## Electrical Solenoid Change - P/N 89-96158

This is a revision of Outboard Service Bulletin 91-34. Destroy Bulletin 91-34 and insert Bulletin 91-34A. Revision is due to a change in solenoid supersession.

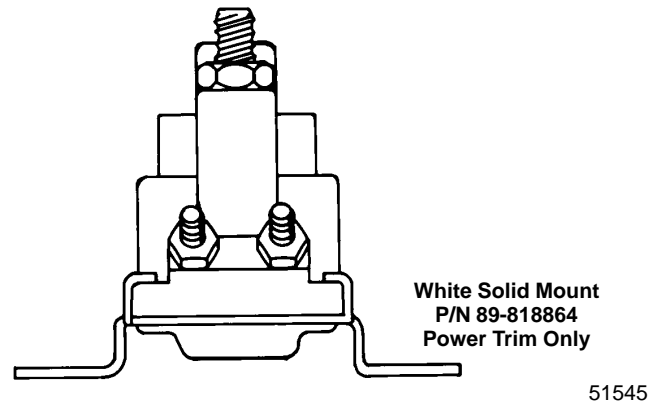
The black electrical solenoid P/N 89-96158 is installed on a variety of models as a starter motor solenoid and as a power trim solenoid. Two changes have occurred:

1. A more durable solenoid for power trim application has been developed and is identified by a white housing.
2. Rubber mounts were added to both the black and the white solenoids.

The new longer duty cycle power trim solenoid is more durable and colored white (natural) for easy identification.

**STARTER MOTOR - USE BLACK SOLENOID ONLY**  
P/N 89-96158 solid mount

**POWER TRIM - USE WHITE SOLENOID ONLY**  
P/N 89-818864 solid mount

- Power Trim - install the new white solenoid P/N 89-818864.
- Starter Motor - install the black solenoid P/N 89-96158.
